# **Joint response of Suffolk Coastal District Council and Suffolk County Council to EDF Energy's Stage 3 Public Consultation**

***The following appendix is the draft response subject to agreement of the report by Suffolk County Council Cabinet and Suffolk Coastal District Council Cabinet.***

**March 2019**

#### *Stockpiling*

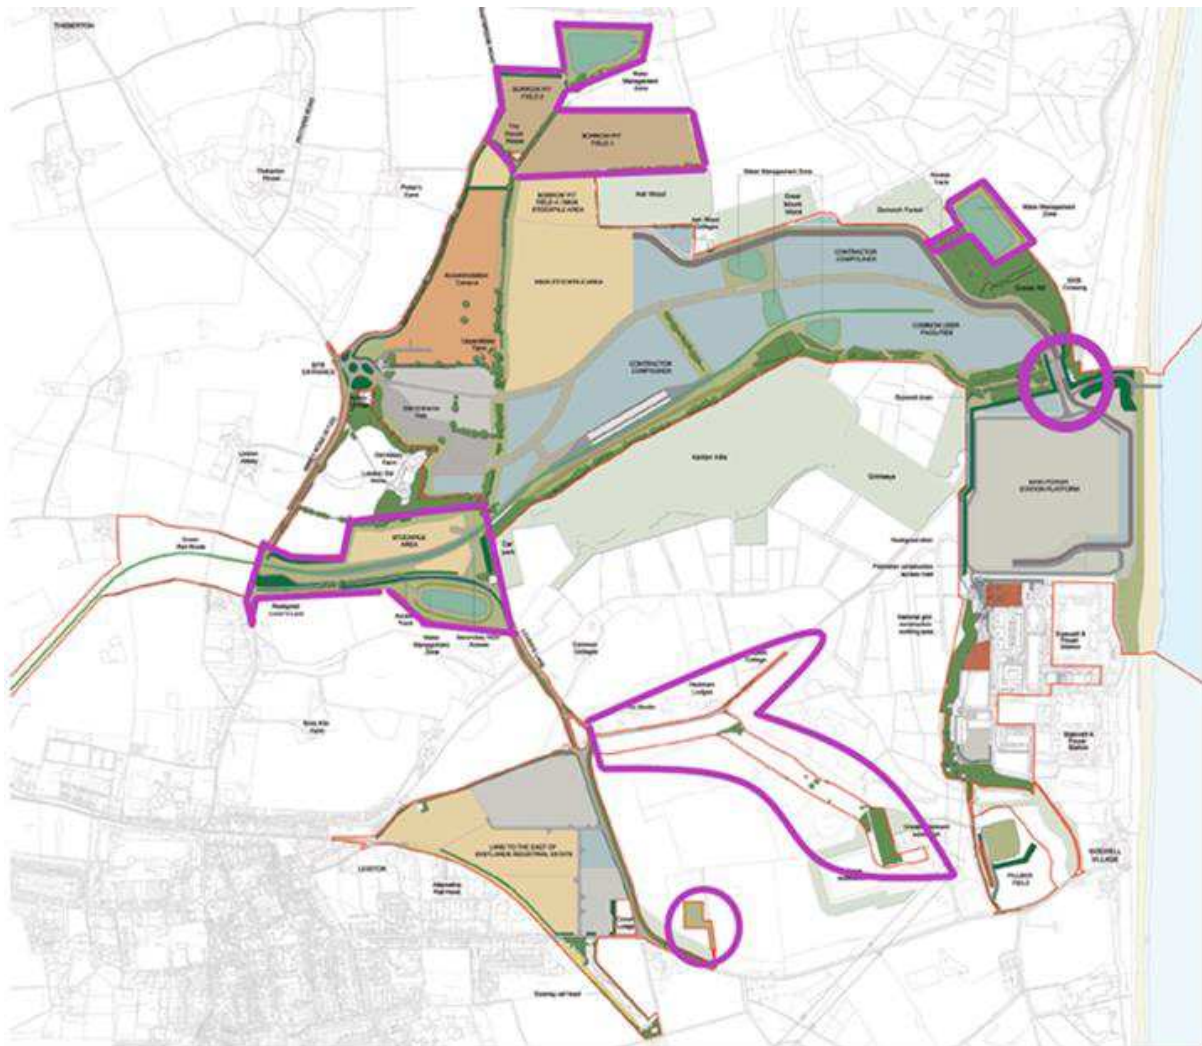
616. The main stockpile area will be on land to the east of Bridleway 19 and at its maximum will be up to 35 metres high – it is likely to reach this peak a few years into construction and will then reduce. It would have access ramps of 1:8 and a plateau working area on top.

617. Other stockpiles will be between 3.5m - 11m – 15m at peak height. The stockpile on the LEEIE may be up to 15m, HGVs will transport material from the LEEIE to the main construction site. There will be landscaping of the borrow pit and stockpile areas.
